Product Bulletin # TDS-236 Rev 2

HMI Top Drive Adjustable Extend Arm Upgrade

Figure 1: Noticeable Tilt of HMI Top Drive

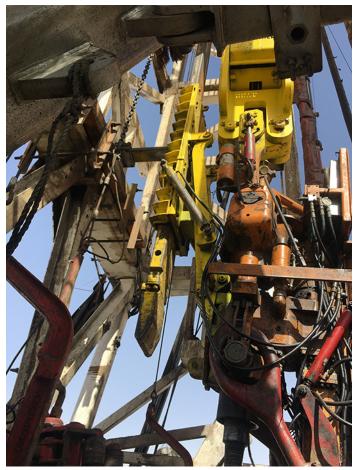
Canrig has requirements for the allowable misalignment of the top drive from the drill stump. (See Product Bulletin TDS-194). Failure to conform to these requirements will result in substantial side loading of the quill. In some cases, this has resulted in the cracking of the quill pin, and/or the Mud Saver Valve (Lower Well Control Valve), causing major equipment failures and safety hazards.

Most Canrig top drives have the means to adjust the tilt of the top drive by adjustment on the torque arrest system. However, model HMI top drives are not equipped with such a tilt adjustment. Canrig has recently released an upgrade kit that allows for the tilt adjustment of HMI top drives by replacing the fixed length extend arms with adjustable length arms.

Inspect your top drive to ensure that it meets the well center alignment criteria shown in Product Bulletin TDS-194.
